**1. Bulletin ID #:** B-01-DT-10-20.R1

**2. Reference Document:** "Technical Interconnection Requirements (TIR) for Distributed Generation Micro Generation & Small Generation, 3-phase, less than 30 kW", *DT-10-20 R1*, April 1, and all preceding versions. The original document published as DT-10-20 R0 in 2010.

**3. Type:** Modification of Section 5.3.2 System Requirements

Section 5.3.2: Microgeneration (10 kW or less) System Requirements

## P(V) characteristics

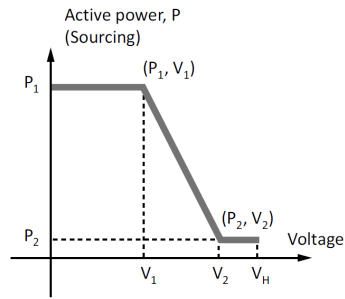
(a) Line sections where the total generation, including the proposed generator exceeds 7% of the annual line section peak load may be considered for connection with additional requirements including:

1. Inverters must be UL1741SA (or later) certified or CSA 22.3 No. 9:20.
2. Smart inverter settings may be subject to Hydro One review and approval.
3. Prior to connection the facility must be capable of power factor set-point changes (ie. field adjustable) at all times.

## Volt-watt parameter settings for DER settings

<b>P(V) parameters</b>	<b>HONI default parameter values for DER systems</b>
V1	1.051 p.u.
P1	Rated Power
V2	1.061 p.u.
P2	0 kW
Open loop response time	10 sec
